Re: Burwood Place – Response to Request for Further Information

Gyde Consulting (Gyde) represents Burwood Tower Holdings Pty Ltd, the applicant for a modification application located at 42-60 Railway Parade, Burwood, also known as Burwood Place (Council Ref: DA10.2021.44.5).

Table 1 RFI Response

Figure 1 Extract of annotated and clouded photomontage (Source: Studio SC)

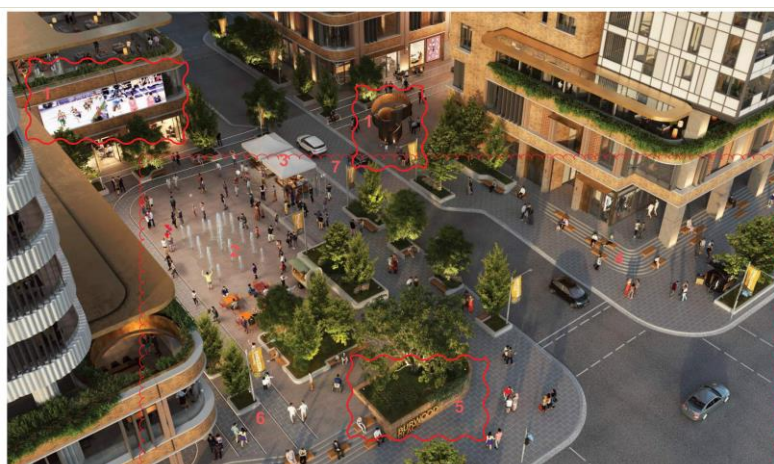
Council Comment	Response
1.	Complete public domain plans and associated works with many of the ideas shown on photomontages only but not on drawings.	Photomontages have been updated to accurately reflect the current architectural and landscape plans. While the photomontages themselves are not to be stamped as approved documents, the architectural/landscape plans are, and the updates ensure consistency between these materials. It should be noted, however, that certain elements depicted in the photomontages, particularly within the public domain, remain subject to detailed design development. This includes matters governed by Condition 141, which requires the submission of detailed public domain and landscape plans, Condition 20, which required approval of the detailed design of Wynne Avenue and Condition 23, which requires a detailed Public Art Plan. As such, features such as public art installations, electronic display screens, design of Wynne Avenue and other public domain treatments shown in the photomontages are indicative/conceptual only and will be further refined through the relevant post-approval processes. Additionally, the photomontages have been updated to include annotations and clouding, to clearly demonstrate what in each photomontage has been amended when compared to the approved design (refer to the below example).

Figure 2 Planter seating (Source: Place Design Group)

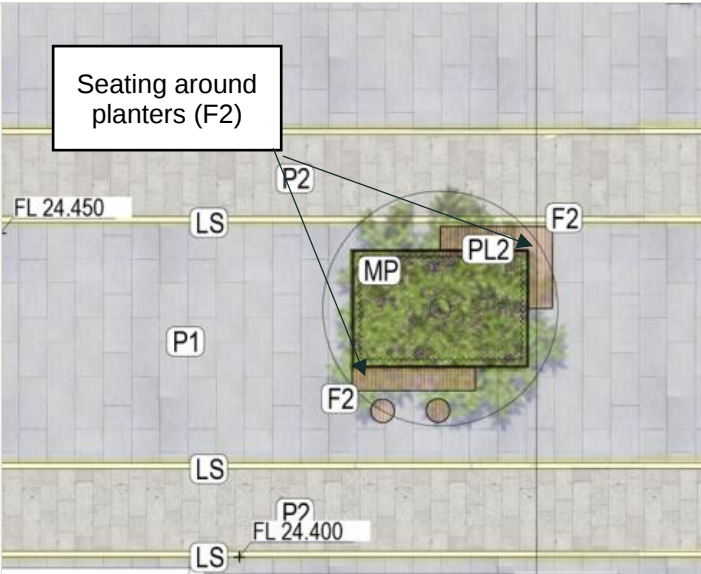
3. The use of raised planters and stepped levels should reflect how people will perceive and move through the space, particularly in a retail and dining context such as Clarendon Place. The inclusion of casual seating on planter walls should also be explored to enhance activation, amenity, and utilisation	Detailed Landscape Plans have been provided by Placed Design Group and provided at Appendix 2. The proposed design for Clarendon Place (refer to below extract) and the connected laneway responds directly to the need for activation and amenity in a retail and dining context through the integration of raised planters that guide movement and provide natural edges for social interaction. Casual seating has been incorporated into planter walls using the Quatro Design integrated timber bench (Product Code: T4SLR), constructed with spotted gum to offer both durability and a high-quality finish. These benches, are strategically located along the length of Clarendon Place and the laneway to encourage informal gathering, rest, and increased utilisation of the public domain. This amendment is proposed under this modification, with further detail being able to be provided under condition 140 of the original development consent.

Figure 3 Section Extract of adjoining Council development (Source: Studio SC)

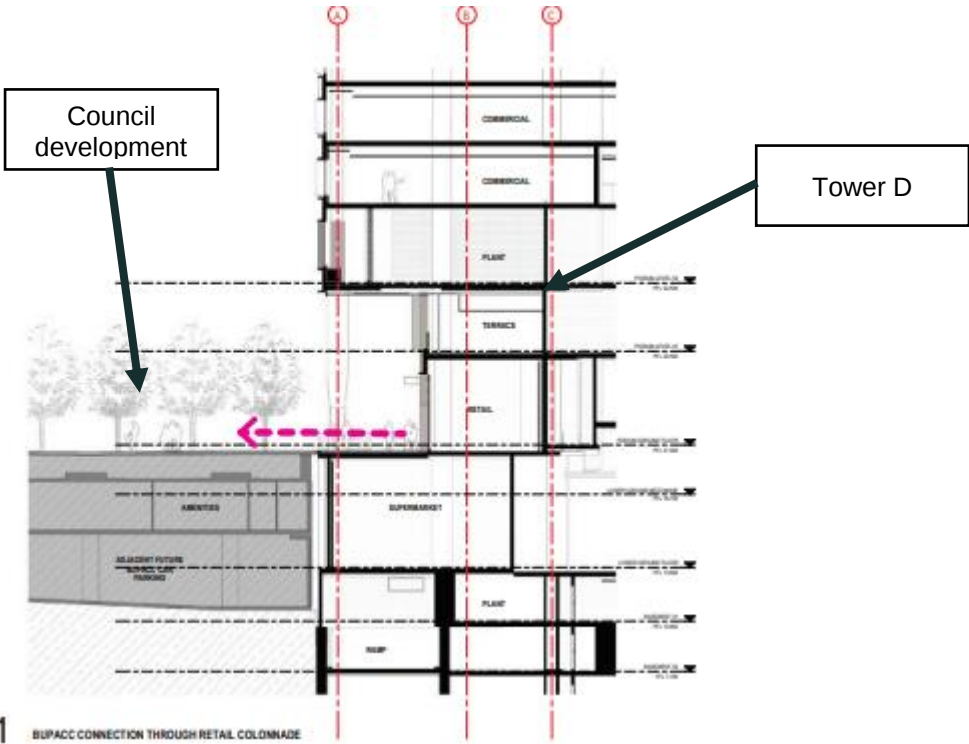
4. Plans referencing the adjoining approved cultural centre/amphitheatre (adjacent to Tower A podium) are to be supported by site sections to confirm the relationship between the proposed and adjoining developments.

Studio SC have provided additional site plans and sections (refer to **Appendix 1**) showing the modified development's relationship with the neighbouring Council cultural development. It should be noted that these plans have been prepared using the latest designs for the Council development.

Figure 6 Tower A Rooftop Plan (Source: Studio SC)

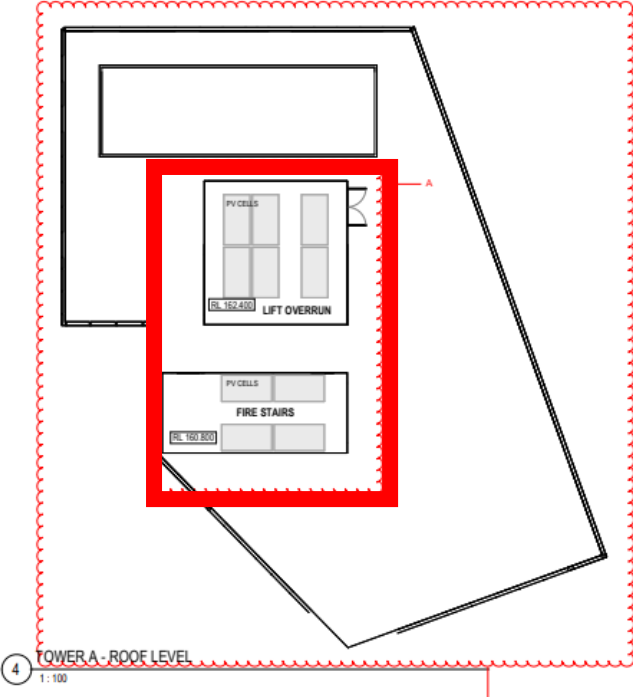
11.	Revised plans must clearly show the proposed roof-level photovoltaic system in both 2D and 3D formats.	The photovoltaic system is already shown on the submitted architectural plans, as shown in the below extracts, highlighted in red.  The diagram is a 2D architectural plan of a rooftop, labeled 'TOWER A - ROOF LEVEL' with a scale of '1:100'. It shows the layout of the roof with various functional areas. A red dashed line outlines the entire roof area. Within this, a red solid rectangle highlights two specific sections. The upper section is labeled 'PV CELLS' and 'LIFT OVERRUN' with a level marker 'RL 152.400'. The lower section is labeled 'PV CELLS' and 'FIRE STAIRS' with a level marker 'RL 150.800'. A red letter 'A' is positioned to the right of the upper section. A small circle with the number '4' is located at the bottom left of the plan.

Figure 10 Planter box details (Source: Place Design Group)

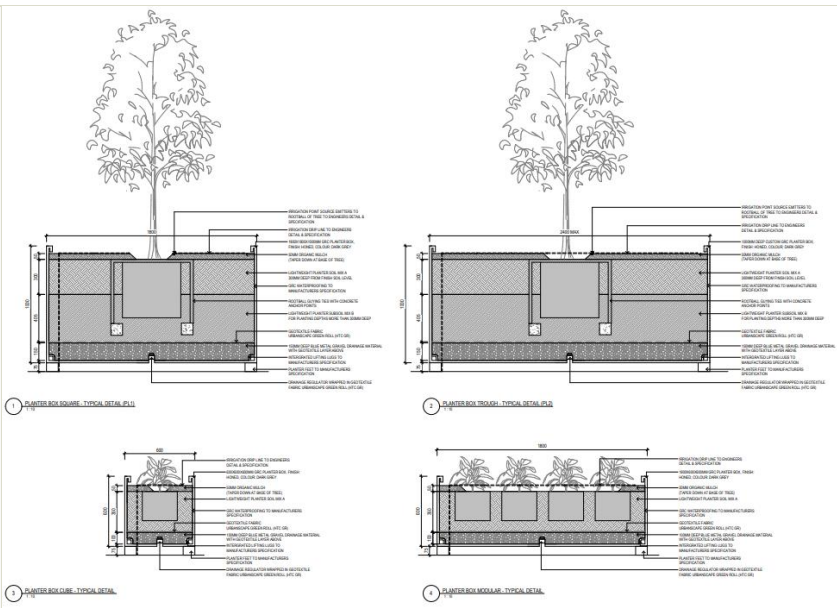
associated with façade materials.					
Principle 5 – Landscape						
14.	The Panel does not support the reduction of landscaped areas within the laneway to accommodate potential future flexibility. A consistent and adaptable landscape treatment is required to support long-term retail activation and public use.	Refer to Detailed Landscape Plans prepared by Place Design Group (Appendix 2) and extract below. Increased soft landscaped areas have been reinstated within the development’s laneways to provide more usability for visitors with larger raised planters and additional integrated seating opportunities. <table><tr><th>Originally Proposed</th><th>Updated Proposed</th></tr><tr><td> LEGEND B - Removal of landscape planters along laneway of Building A and Building B <i>Removal of planters is necessary to allow for greater</i> </td><td> Additional landscape areas proposed </td></tr></table>	Originally Proposed	Updated Proposed	 LEGEND B - Removal of landscape planters along laneway of Building A and Building B <i>Removal of planters is necessary to allow for greater</i>	 Additional landscape areas proposed
Originally Proposed	Updated Proposed					
 LEGEND B - Removal of landscape planters along laneway of Building A and Building B <i>Removal of planters is necessary to allow for greater</i>	 Additional landscape areas proposed					
15.	Concerns are raised about on-slab planting and its long-term viability for tree health, urban canopy targets, and the overall building presentation. Raised planters must provide minimum soil depths with appropriate irrigation and drainage systems to sustain canopy species and ground cover.	Please refer to the Landscape Plans prepared by Placed Design Group (L00-AA961 & L00-AA962- PLANTER BOX DETAILS) at Appendix 2. The below extract of the planter box details address concerns about the long-term viability of on-slab planting by providing minimum soil depths of 1000 mm for canopy trees and 600 mm for groundcovers and shrubs, in line with best practice guidelines. Each planter incorporates an integrated system of drainage (including geotextile filter fabric, gravel drainage layer, and agricultural drains), waterproofing membranes, and root barriers to support healthy root development and protect the structural integrity of the building. Additionally, provision for automated drip irrigation ensures consistent moisture levels, while the use of AS 4419-compliant growing media further supports plant health. Together, these features ensure the planters can sustain healthy canopy growth over time, contributing meaningfully to urban greening targets and enhancing the building’s presentation.

Figure 11 Approved Basement Level, development boundary highlighted in red (Source: Cox Architecture)

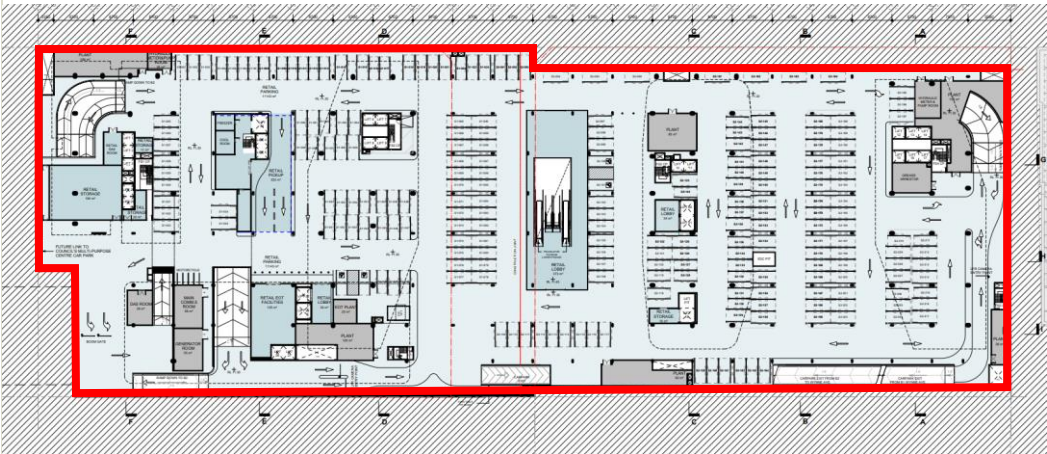
16. Raised planter boxes are not an acceptable substitute for deep soil zones. Opportunities to increase deep soil planting across the site must be explored and adopted where possible.

In response to the Panel's comments regarding deep soil zones, we note that the site is subject to basement levels that extend across the entire site area. As such, no deep soil planting is proposed, nor was it included in the original development approval nor envisaged during the Planning Proposal process. This is demonstrated in the basement level extract below, which formed part of the original development approval. It shows that the basement was approved to extend across the entire site (boundary to boundary), meaning no deep soil areas were ever proposed or approved.

Figure 12 Podium Planting Details (Source: Place Design Group)

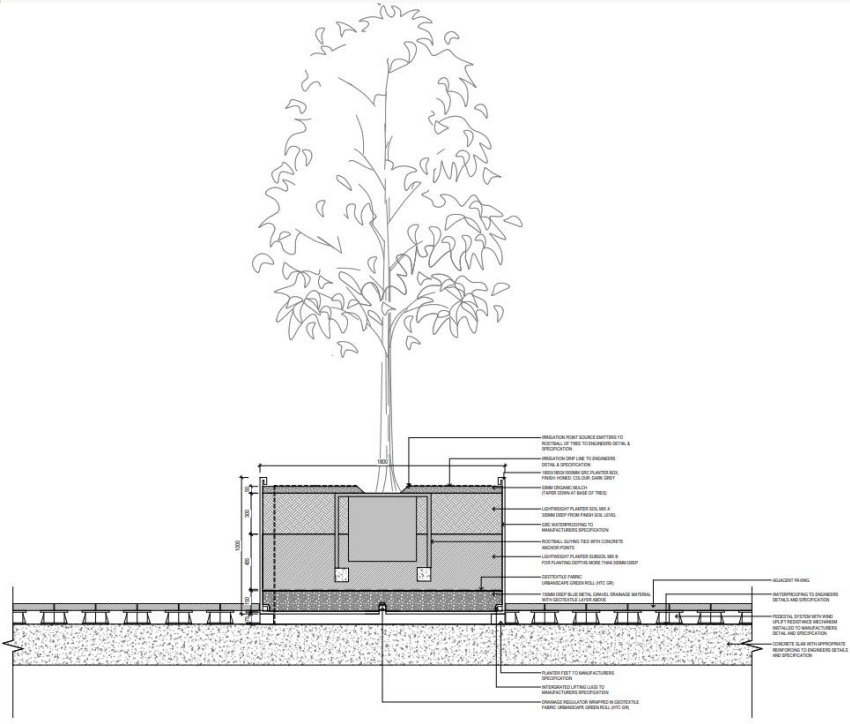
17. The landscape package must include 1:20 scale design intent sections to show irrigation and drainage of upper-level planting. A strategy is also required for removal of green waste from planters on structures.

The below extract section, scaled at 1:10 @ A1, provides the required level of design intent to demonstrate the irrigation and drainage provisions for upper-level planting (specifically along the podium levels). The detail clearly illustrates the inclusion of a geotextile-wrapped gravel drainage layer, agricultural drains, waterproofing membrane, and root barrier, ensuring effective water management and protection of the building structure. It also shows provision for automated drip irrigation to maintain consistent soil moisture.

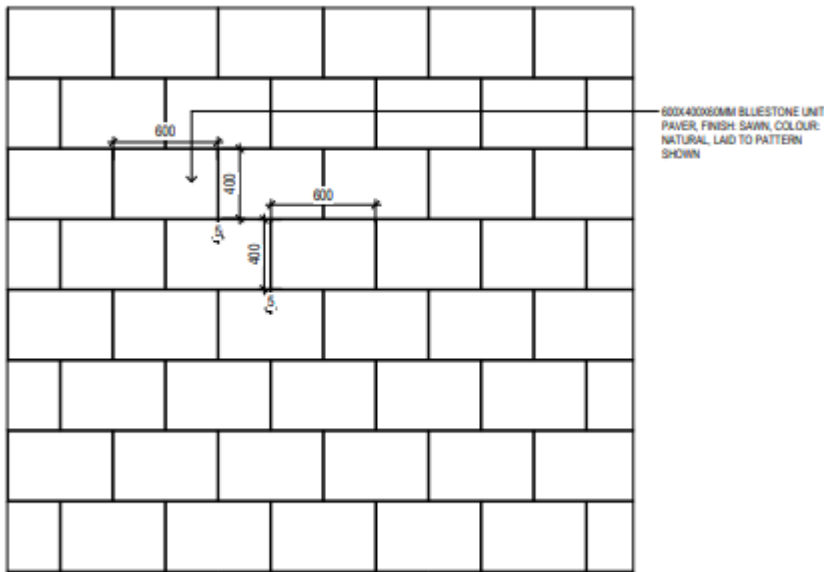
29. The three undercroft areas along the laneway should be considered for suspended public art installations. A revised Public Art Strategy is required.

We note that no changes are proposed to the approved Public Art Strategy under this modification application. The existing strategy already contemplates artistic elements in these locations (refer to below figure), and Condition 23 of the development consent (refer to below extract) requires a detailed Public Art Plan to be submitted prior to the relevant Construction Certificate. This future submission will allow for further refinement of artwork placement, including consideration of suspended installations in the undercroft areas.

Figure 14 Street furniture details (Source: Place Design Group)

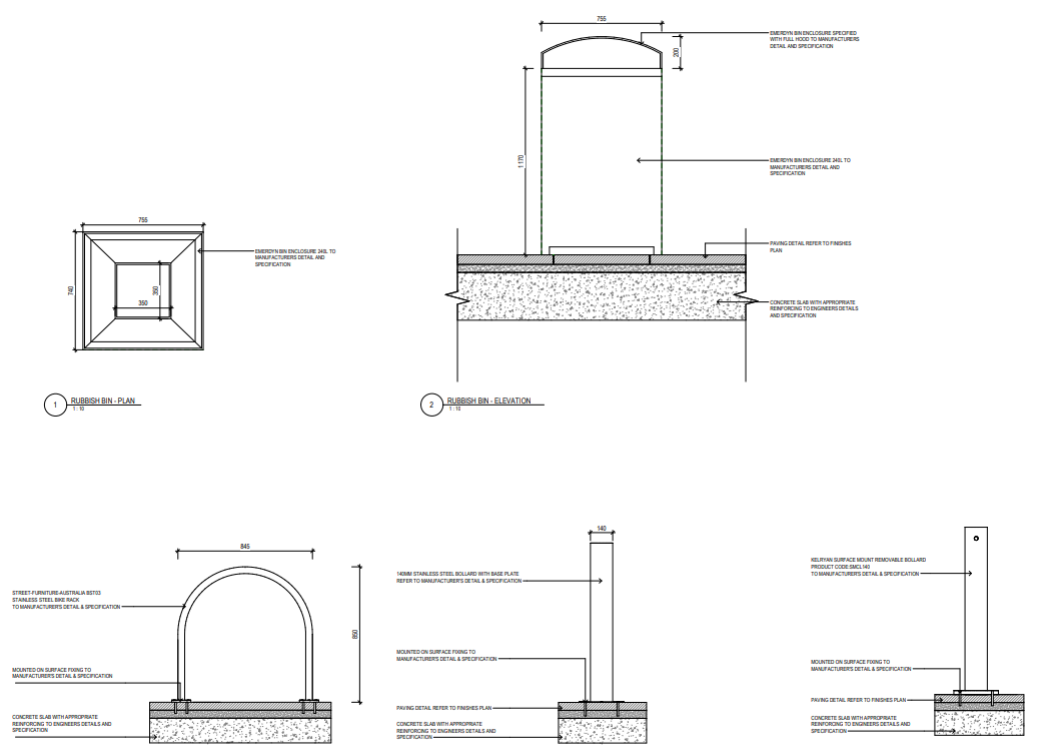
49.	Street furniture (e.g. bins, seating) must be detailed.	Street furniture items have been detailed in the updated Landscape Plans prepared by Place Design Group (Appendix 2), including bins, benches, bike racks, bollards, and communal seating, as illustrated in the below extract images and typical design drawings. Specific products include the Quatro Design integrated timber bench (T4SLR), Linea

powdercoated bench, Jack & Jill picnic setting, Frog GRC lounge seat, standard stainless steel bike racks, and bin enclosures (EMDZ-240), among others. These are supported by dimensioned elevations and material specifications, with further street furniture types also identified on the landscape plans.
